**20221027-ABP-314232**

**Ref: 314232**  
**App: Córas Iompair Éireann**  
**For: DART+ West Railway Order - Dublin City to Maynooth and M3 Parkway Railway Order Application**

Thank you for referring the above railway order application to An Taisce for comment.

### **Castleknock Rail Bridge –Demolition and rebuilding.**

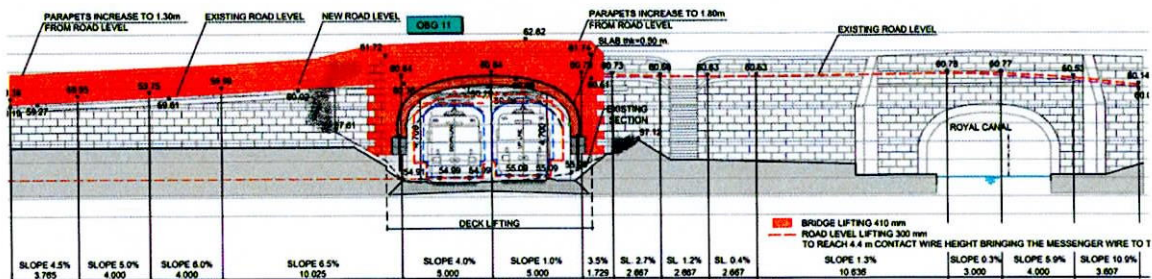
Rather than demolish and rebuild this historic structure (dated 1845), to achieve an extra height of just 40cm, we recommend that the better and sensible alternative of the combination

of track lowering, and the installation of a reduced height overhead line equipment (OHLE) be adopted, for the reasons explained in the previous entry for the Broombridge Rail Bridge.

The change of design and construction approach here is especially important with regard to how critical this bridge is to road transport and active travel infrastructure.

### Leixlip Confey Station Rail Bridge - Demolition and rebuilding.

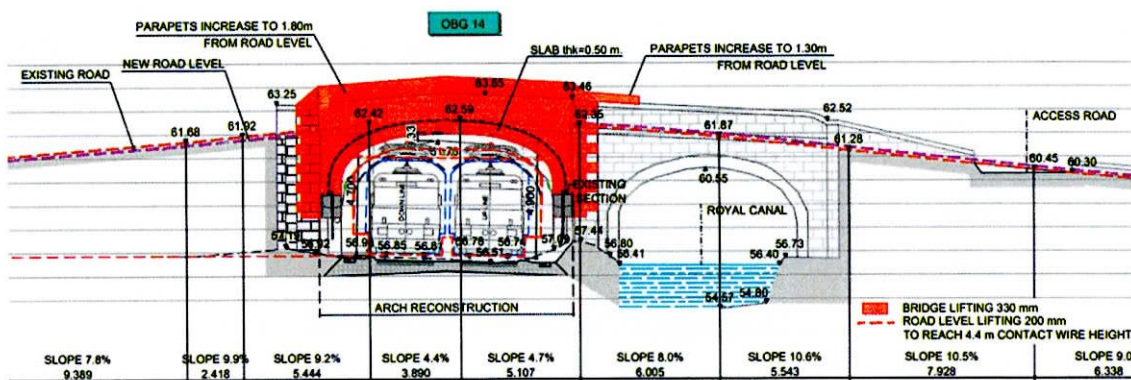
As a better alternative than to demolish and rebuild this historic structure from 1845, to achieve an extra height of only 30cm, we recommend that the combination of track lowering be followed, and the installation of a reduced height overhead line equipment (OHLE) for the reasons explained in the previous entry under Broombridge, be adopted.

### **Coolmine – New Pedestrian / Cycle bridge**

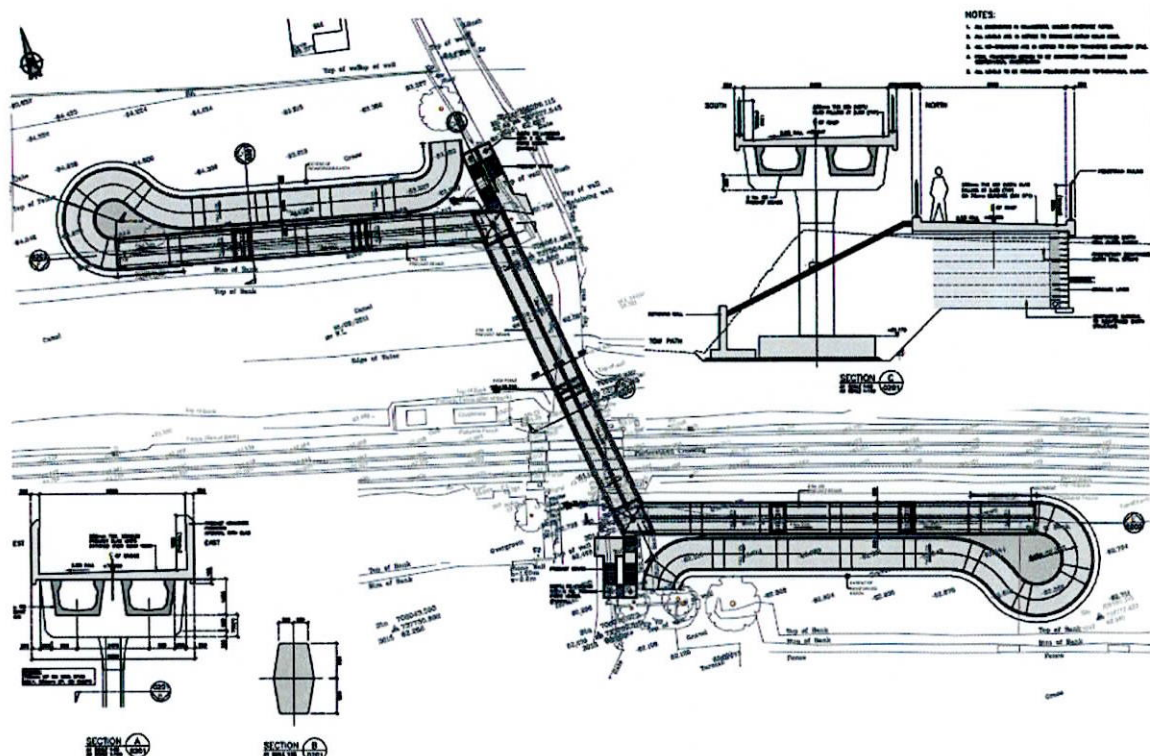
From the Coolmine level crossing and across the canal bridge, one can see that both the design and the alignment of the bridge on the northern bank of the Canal would be crucial to the successful implementation of this project. We would recommend that the project team consider retaining as many of the mature trees as possible and endeavour to preserve the rich ecology of the canal bank here, thereby retaining this location's semi-rural character by carefully re-aligning and/or flipping the proposed ramping of the bridge and associated vertical supports several metres towards Sheepmore Lane, so as to allow for this retention.

We note that the design and construction detailing of this bridge has been amended in to be a *COR-TEN®* clad lightweight steel structure, which we had recommended in our previous submission, which is welcome.

Finally, in order to comply with the ethos of universal design and the fact that Irish Rail are currently installing lifts around the country as part of the 'Big Lift' we recommend accessible lifts be provided.

#### Option 1-Pedestrian, Cycle & Mobility Impaired Bridge General Arrangement - Sheet 1 of 3

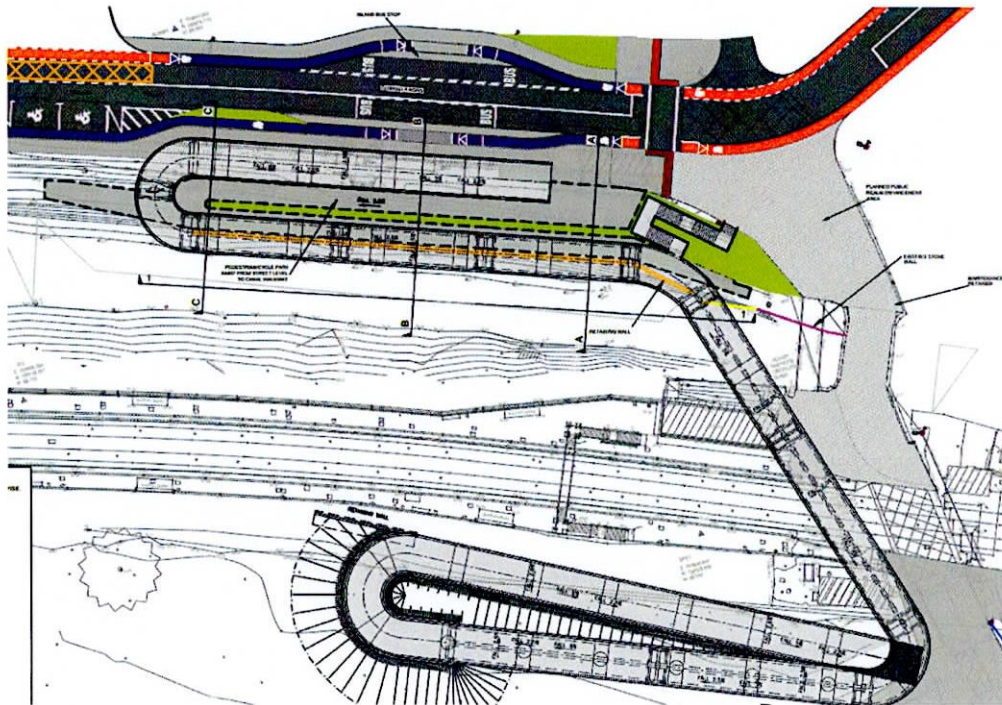
From this excerpt from *Clonsilla-Option 1-Pedestrian, Cycle & Mobility Impaired Bridge General Arrangement - Sheet 1 of 3*, it is indicated that this will involve the clear felling of all existing mature trees and hedgerow along the northern bank of the Royal Canal and that the rich ecology of the hedgerow down to the towpath will be lost.

Excerpt from *Plans, Elevations and Sections* – Sheet 2 of 3

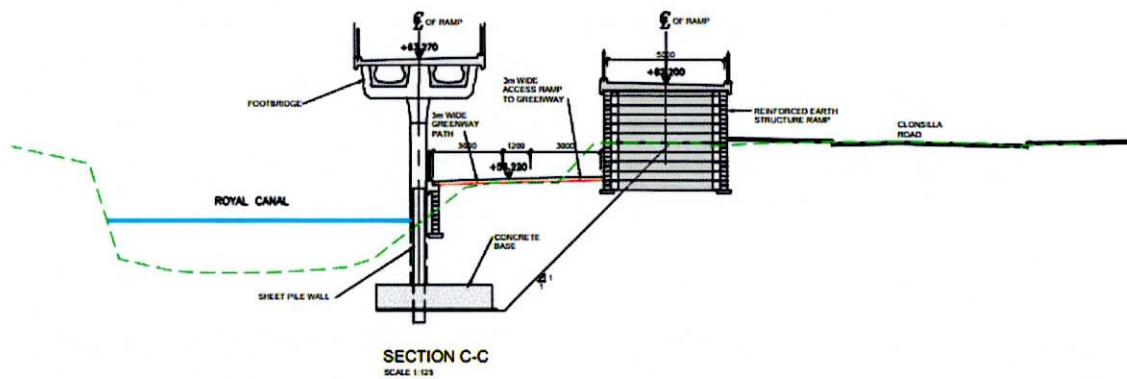
From the above section and plan one can imagine that the visual impact of the 6m wide bridge ramp in this location which retains a rural and wooded character would be significant, as would the 4 to 6m high massive concrete stanchions that will be cut into the Royal Canal bank, which would have visual impact on the character of the place as well as the canal's rich fauna and flora.

We therefore recommend that the construction detailing of this bridge should also be reconsidered to avoid vertical supports cutting into the Royal Canal (which is a Natural Heritage Area) and its adjacent tow path.

It is accordingly recommended that the lightweight steel structure proposed for Ashtown and Coolmine be selected as an alternative to a visually massive prefabricated concrete system build which has been selected in the railway.

We also recommend that the COR-TEN® clad lightweight steel structure proposed for Ashtown and Coolmine be selected as an alternative to the proposed visually massive prefabricated concrete system build due to the sensitivity of this location.

Finally, in order to comply with the ethos of universal design and the fact that Irish Rail are currently installing lifts around the country as part of the 'Big Lift' we recommend accessible lifts be provided.
